Amendments to the Drawings

Attachment: Replacement Sheets

FIG. 2

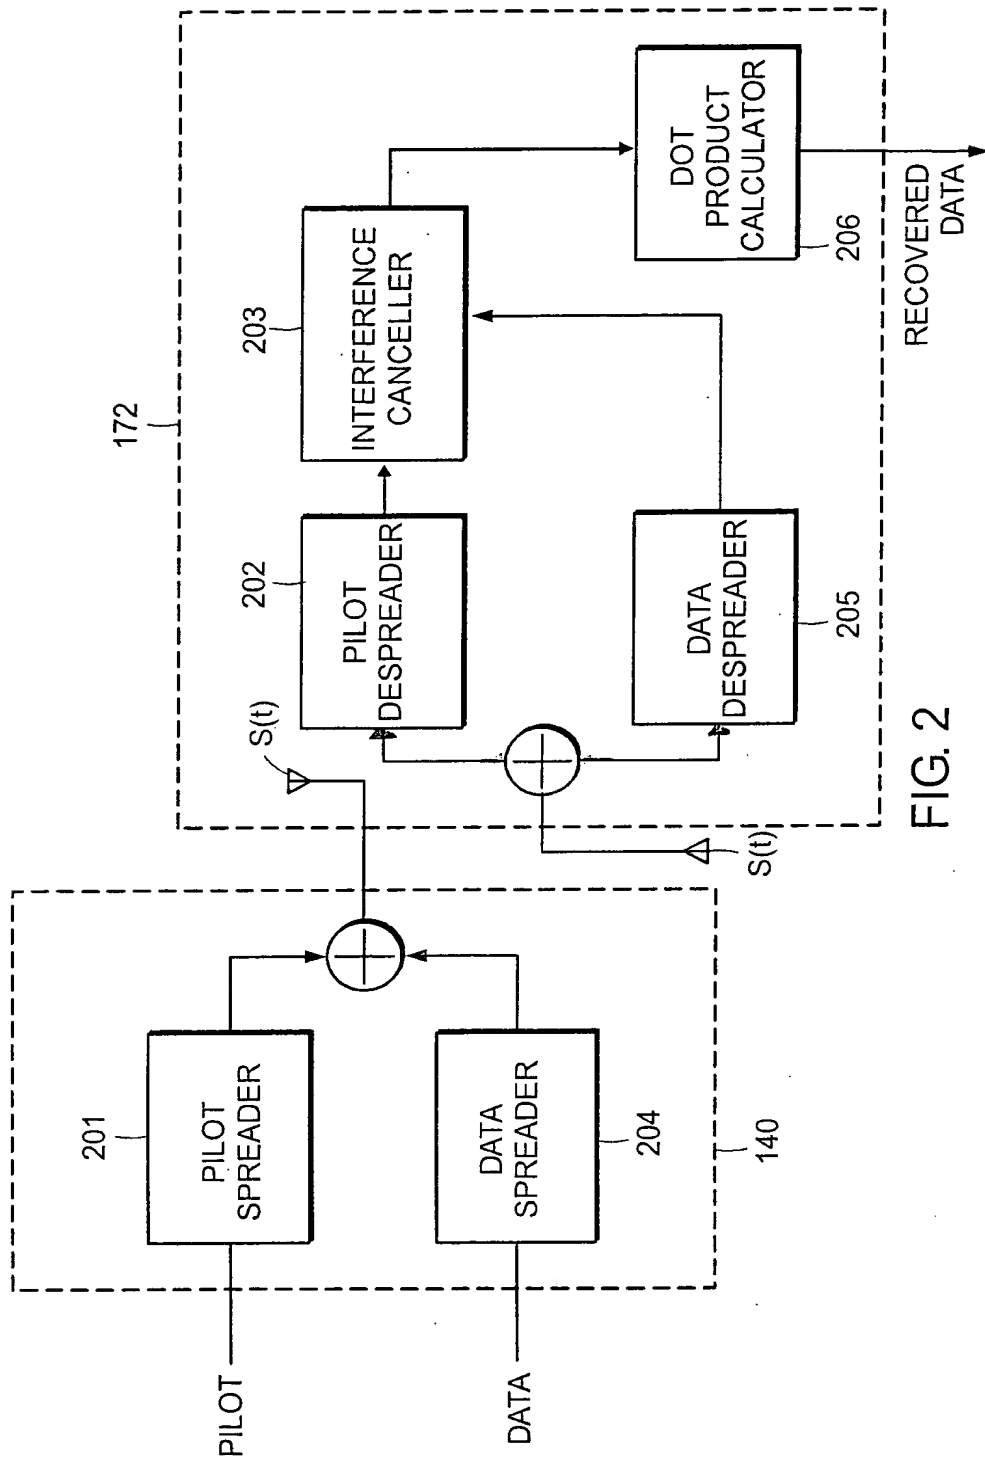
The Examiner objected to the drawings stating that the quality of the informal drawings is poor. Specifically, the Examiner stated that with respect to Figure 2, element 172 is difficult to read the labels on the figure. Further, the Examiner stated that the numerical labels on Figures 3-7 are difficult to read.

Applicants file herewith are replacement drawings. Specifically, sheets 1-9, including Figures 1-8B, are now filed in this patent application. Applicant believe that these objections to the drawings are now overcome.
